MFN No. 040-94  
Docket STN 52-004

Subject: NRC Requests for Additional Information (RAIs) on the Simplified Boiling  
Water Reactor (SBWR) Design

**RESPONSES TO NRC REQUEST FOR ADDITIONAL INFORMATION (RAI)  
SIMPLIFIED BOILING WATER REACTOR  
SSAR CHAPTER 7, INSTRUMENTATION AND CONTROLS**

**Figure 420.29-1 Block Diagram  
 Neutron Monitoring System APRM Trip To SSLC**

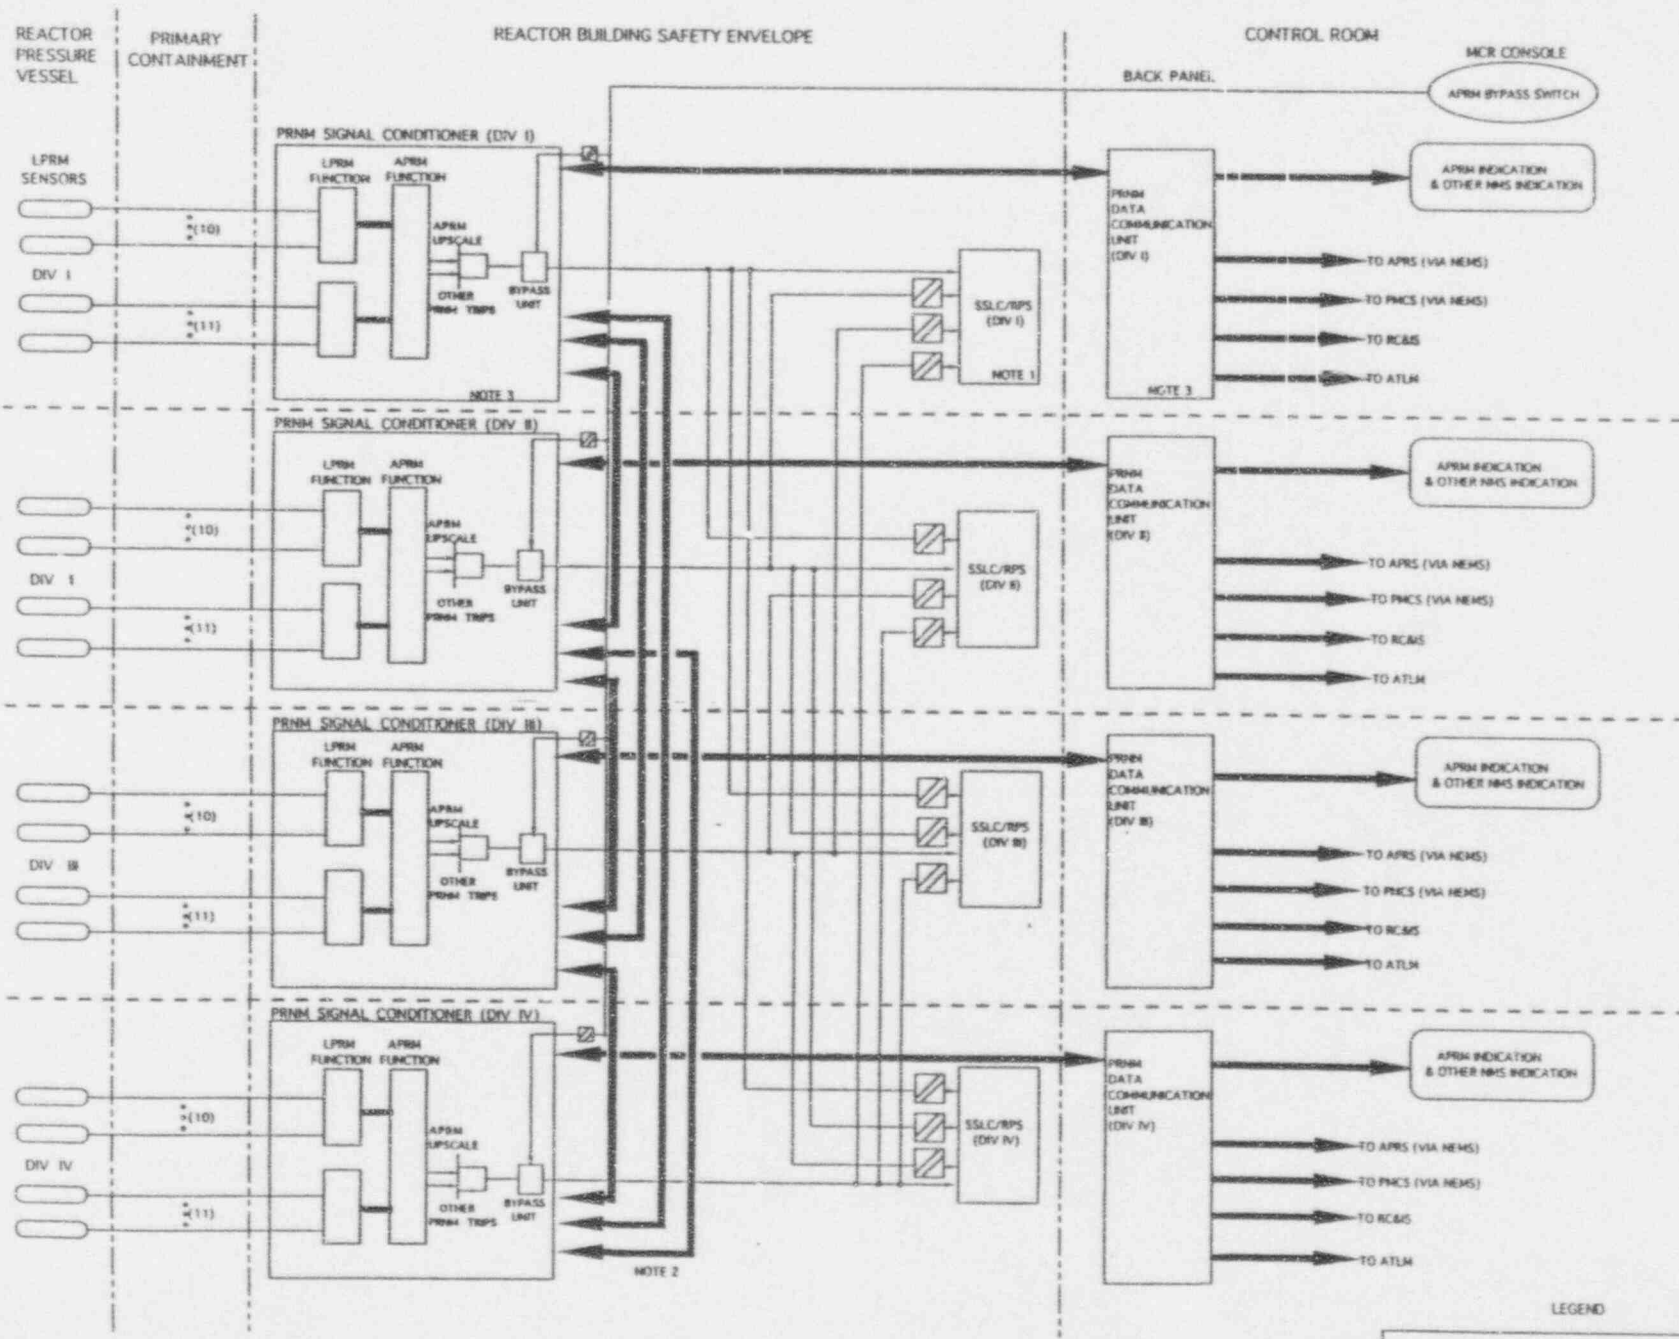
Using block diagrams, describe the operation of the reactor protection and safety monitoring system for a average power range monitor upscale trip. The description should trace the transmission of the initiating signals from the sensors through the integrated protection cabinets, the engineered safety features actuation cabinets, and the monitoring and controls at the control room work station to the actuated devices. The diagram should also include all the major components, such as the sensors, the signal conditioners, the isolation devices, the multiplexers, the data buses, the indicators, the protection cabinets, and control rod drive system. The diagram should show all channels and components and interfaces. (Reference SSAR Section 7.2.1.)

See attached Figure 420.29-1 of NMS block diagrams. Figure 420.29-1 shows the initiating signals from the sensors, through the signal conditioner, to the reactor protection system. Figure 7.3.2B of the SBWR SSAR shows the signals from the SSLC/RPS to the actuation devices. The neutron monitoring system safety related trip signals use a dedicated data transmission path to the safety system logic control (SSLC) and reactor protection system (RPS) and do not go through the essential multiplexing system (EMS). Other NMS signals going to the plant monitoring & control system (PMCS) and automated power regulation system (APRS) go through the non-essential multiplexing system (NEMS) first. This is illustrated in Figure 420.29-1. The NMS also has a dedicated data transmission pathway to the rod control & information system (RC&IS) and its subsystem, the automated thermal limit monitor (ATLM).

(Refer to Figure 420.29-1) As shown in Figure 420.29-1, all four PRNM channels are independent and isolated from one another except the inter-divisional communication through the fiber optics pathways. The fiber optics pathways serve as isolation devices. As a result, the isolation criteria between different divisions is satisfied. Testing of each NMS PRNM channel will not violate the isolation criteria.

SSLC BYPASS SCHEME - RPS / MSiV  
Figure 420.43-1

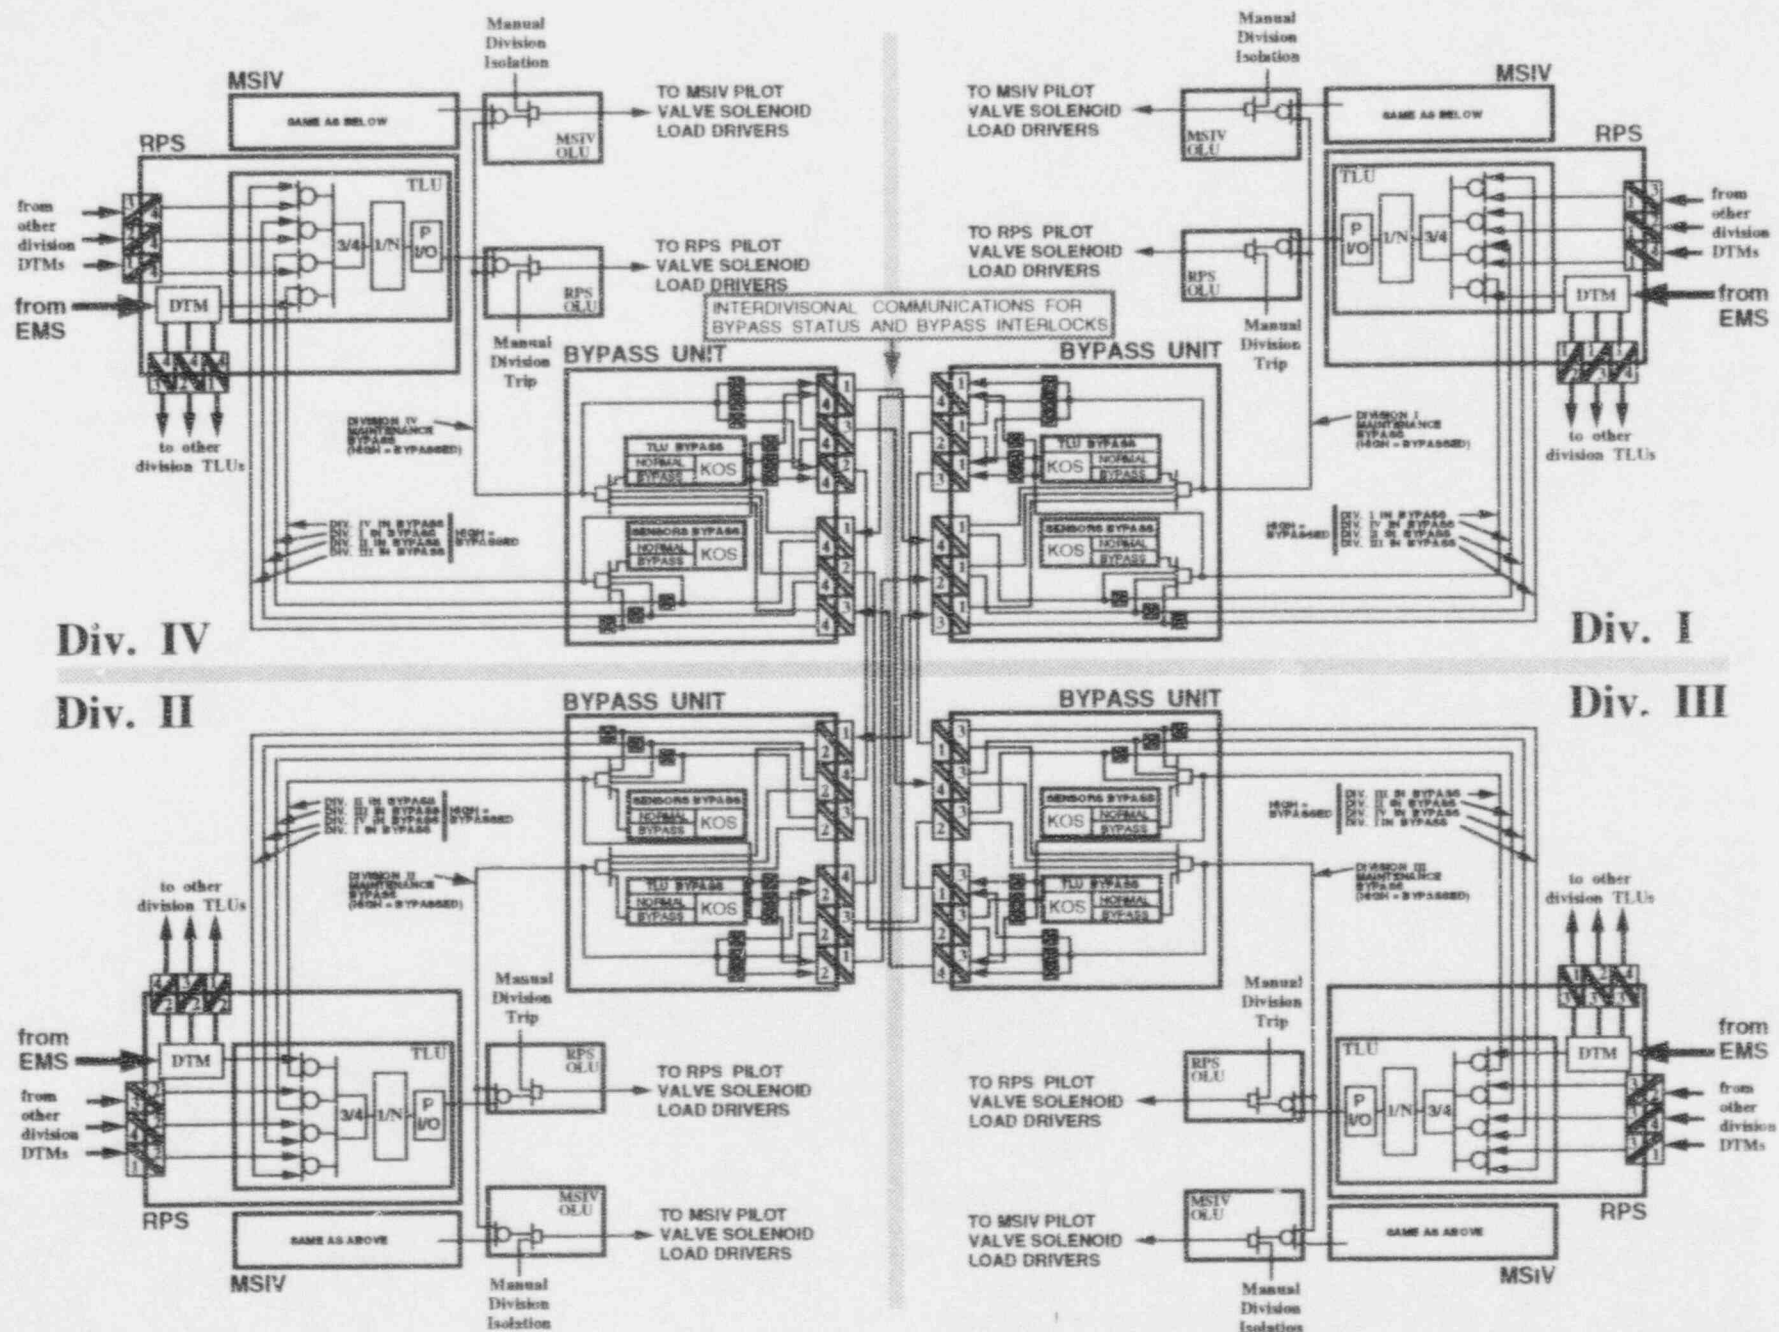
Describe the built-in interlocks that will prevent a simultaneous bypass of more than one channel. Provide a list of bypasses that do not have this interlock capability and provide justifications for not having it. (Reference SSAR Section 7.2.1.3.)

The attached Figures 420.43-1 and 420.43-2 illustrate the Reactor Protection System (RPS) and Engineered Safety Feature (ESF) bypass circuitry, respectively. These figures have been revised from similar ones appearing in ABWR Safety System Logic and Control (SSLC) Hardware/Software System Specification 23A6915, Rev. 0. As described in SBWR SSAR Section 7.3.4.2, two types of channel bypass exist, division-of-sensors bypass and division-out-of-service (or division maintenance) bypass. For division-of-sensors bypass, all sensors in one division are bypassed simultaneously for both RPS and ESF channels; individual sensor channel bypass is not part of the SSLC design. However, individual channels can be placed in a trip condition by applying a simulated trip signal to the Trip Logic Unit (TLU) input for a given failed sensor channel. As shown in the figures, the four divisional bypass units are interlocked so that only one division-of-sensors bypass can be applied at a time.
